JAGUAR

IMPROVED ENGINE SUMP OIL SEALING

SERVICE BULLETIN

REBORING AND FITTING CYLINDER LINERS

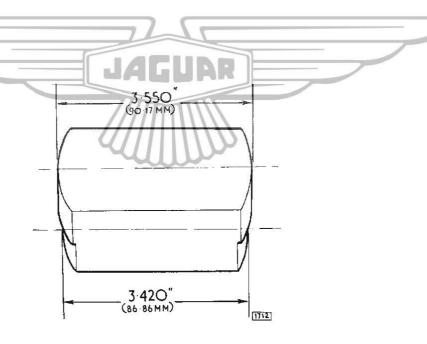
After the engine has been rebored to +.030" (+.76 mm), or if the bores will not clean up at .030", it will be necessary to replace the cylinder liners, bore out to standard and fit standard sized pistons.

The worn liners must be pressed out from the <u>bottom</u> using a stepped block (see illustration).

Press in the new liners from the top and file, or lightly skim, the tops of the liners flush with the top face of cylinder block.

MODIFIED ENGINE OIL FILTER

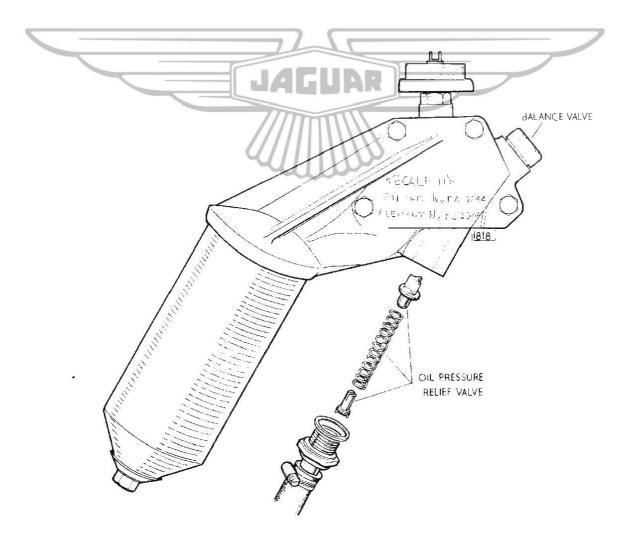
On cars with the above engine numbers and enwards a modified oil filter (Part number C.16296) is fitted. The canister of the new oil filter is inclined downwards and therefore no drain plug is fitted. The oil pressure relief valve is retained by the outlet adaptor to which oil return hose is fitted and must not be confused with the balance valve (see illustration overleaf). The element (Part number 1526 - FG.2306) and sealing ring (Part number 6883) are the same as fitted to the previous type of oil filter.

CYLINDER HEADS

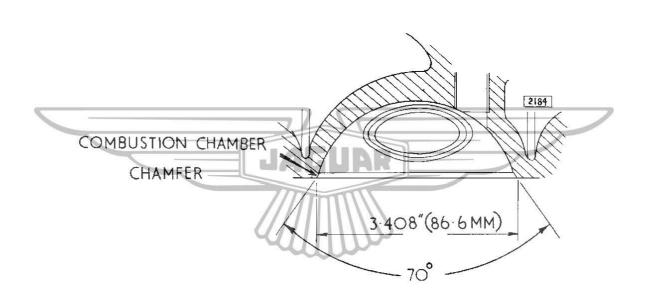
The chamfer machined on the combustion chambers of cylinder heads fitted to 3.8 litre engines (with the exception of the "S" type - Gold top head) is no longer used, thus standardizing the cylinder head casting with those used on 2.4 and 3.4 litre engines. The cylinder head identification colour of dark blue will continue as before.

If replacing either cylinder head or pistons on any 3.8 litre 8 to 1 compression ratio engine, it is essential that the following facts should be noted. (Piston part numbers are stamped on the flat portion of the crown of the piston).

Must only be fitted with C.14806/1 pistons which have a

modified crown to prevent fouling between the piston and cylinder head.

INTERMEDIATE MAIN BEARING CRANKSHAFT CLEARANCE

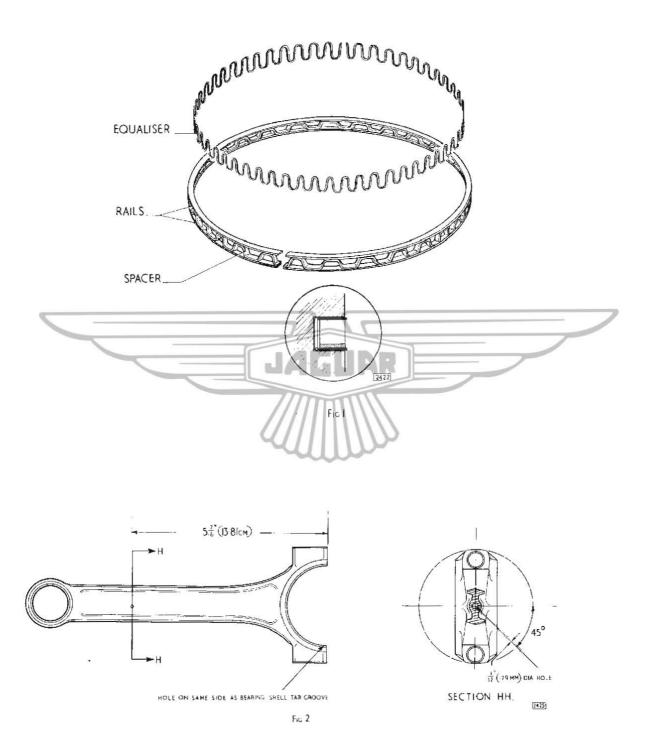
Commencing at the above engine numbers and onwards, the intermediate main bearing clearance is brought into line with the front, centre and rear main bearings. All main bearing journals are now of 2.750" to 2.7505" diameter.

MODIFIED PISTON RINGS AND CONNECTING ROD.

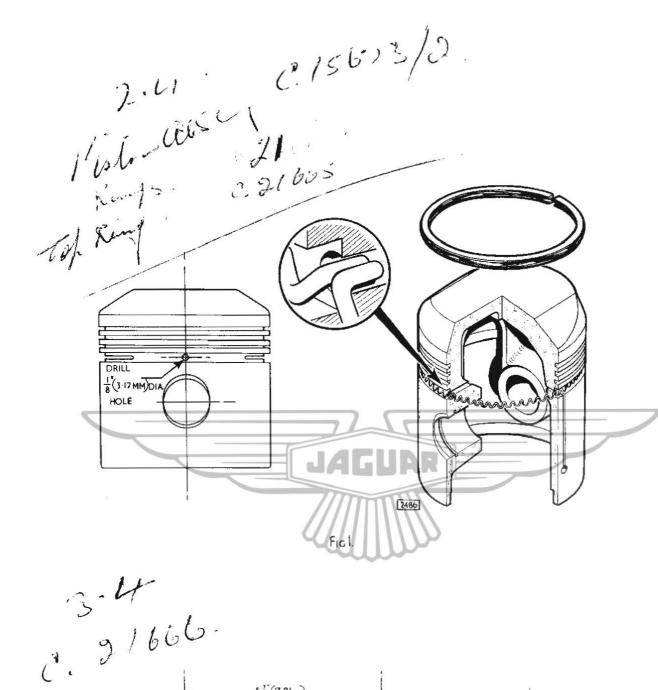
Commencing at the above engine numbers, a new type top compression ring and a steel rail type oil control ring are introduced on 2.4 litre and 3.4 litre engines.

The top compression ring has a $40^{\rm O}$ chamfer on the inner edge which must face the top of the ring groove. The ring is stamped with a "T" on the top face.

- 2.4 litre pistons will require an &" (3.17 mm) hole drilled in the centre of the oil control ring groove in line with the gudgeon pin bore. (See Fig 1)
- 3.4 litre engines must have the connecting rod modified inasmuch as a hole 1/32" (.79 mm) diameter is drilled at 45° and 5.7/16" (13.81 cm) from the centre of the big end bearing bore on the same side as the big end bearing shell retaining groove (See Fig 2). When fitted, the hole in the connecting rod must face forward and be pointing to the thrust (inlet) side of the engine. In the case of the 2.4 litre engine, the connecting rod already includes an oil feed hole.

MODIFIED PISTON RINGS AND CONNECTING ROD.

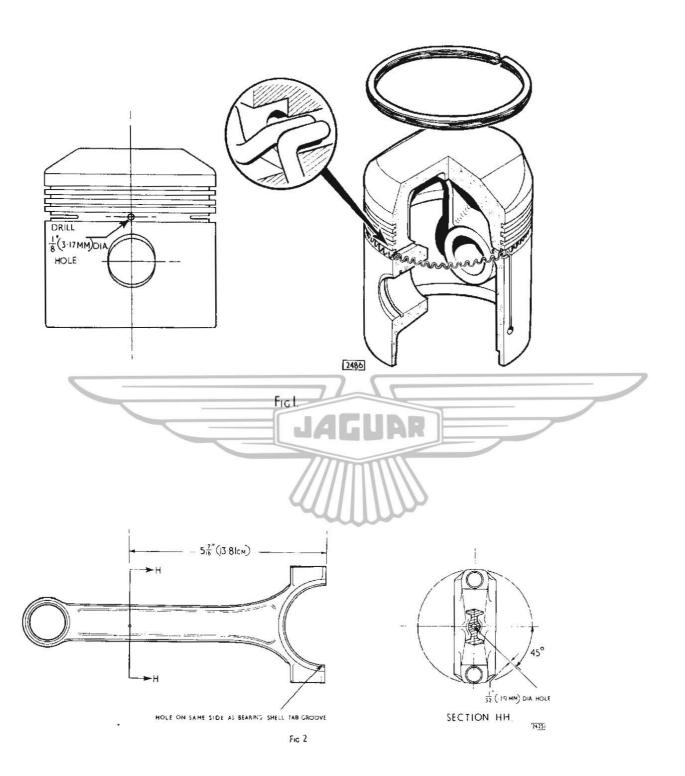
Commencing at the above engine numbers, a new type top compression ring (Part Nos. C.21665-2.4 litre and C.21666-3.4 litre) and a "Maxiflex" steel rail type oil control ring (Part No.C.21664) are introduced on 2.4 litre and 3.4 litre engines.

The top compression ring has a 40° chamfer on the inner edge which must face the top of the ring groove. The ring is stamped with a "T" on the top face.

The new oil control ring consists of two steel rails with a spacer between the two. These rails are held together on assembly with an adhesive. The expander which is fitted inside the oil control ring should be assembled with the two lugs positioned in the hole directly above the gudgeon pin bore.

- 2.4 litre pistons will require an ½" (3.17 mm) hole drilled in the centre of the oil control ring groove in line with the gudgeon pin bore, (See Fig 1), 3.4 litre pistons already have a hole drilled in the ring groove.
- 3.4 litre engines must have the connecting rod modified inasmuch as a hole 1/32" (.79 mm) diameter is drilled at 45° and 5.7/16"(13.81cm) from the centre of the big end bearing bore on the same side as the big end bearing shell retaining groove (See Fig 2). When fitted, the hole in the connecting rod must face forward and be pointing to the thrust (inlet) side of the engine. In the case of the 2.4 litre engine, the connecting rod already includes an oil feed hole.

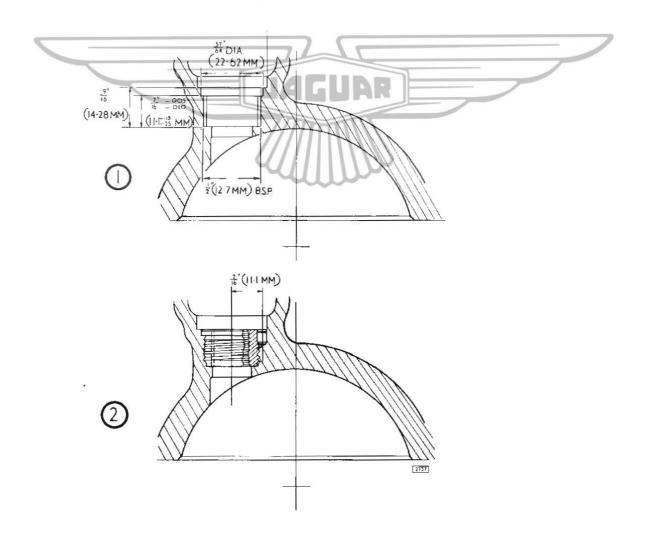
When it becomes necessary to fit a sparking plug insert (C.22381) in the event of a stripped thread, a revised procedure as detailed below should be carried out. This procedure incorporates a locking pin to prevent the insert from being screwed out when removing the sparking plug.

Bore out the stripped thread to .75" (19.05 mm) diameter and tap $\frac{1}{2}$ " B.S.P. as shown in Fig.1.

Make a counterbore 57/64" (22.62 mm) diameter to take the larger diameter of the insert as shown in Fig.1.

Fit the screwed insert ensuring that it sits firmly on the face at the bottom of the thread.

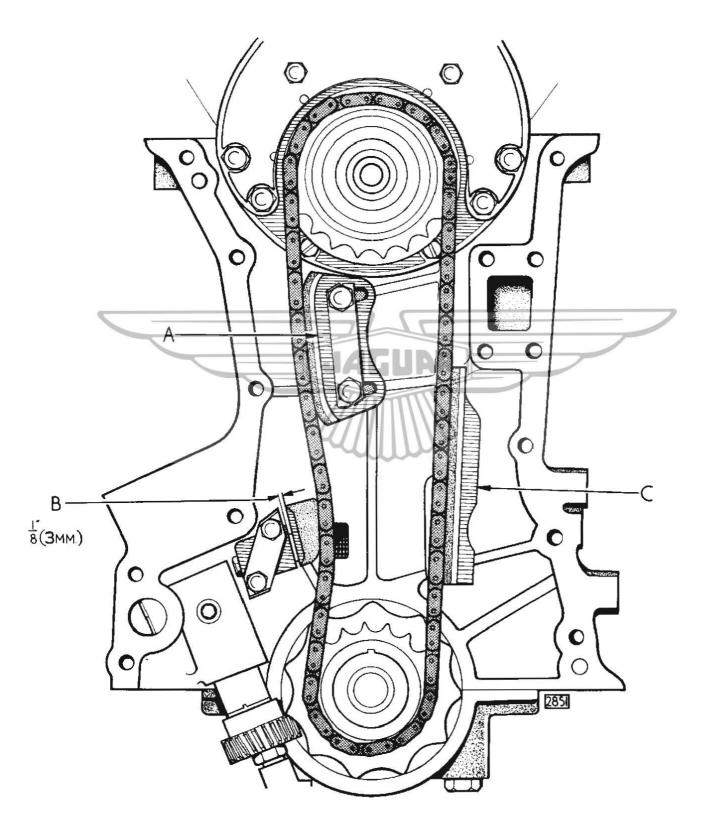
Commencing at the above engine numbers a different type of intermediate damper is fitted to the lower timing chain.

The original type secured to the upper timing chain bracket is replaced by a damper secured to two tapped bosses in the cylinder block (see illustration). Shorter bolts are now fitted to the upper timing chain bracket.

The new damper cannot be fitted in place of the previous type as the cylinder block will not have the tapped bosses.
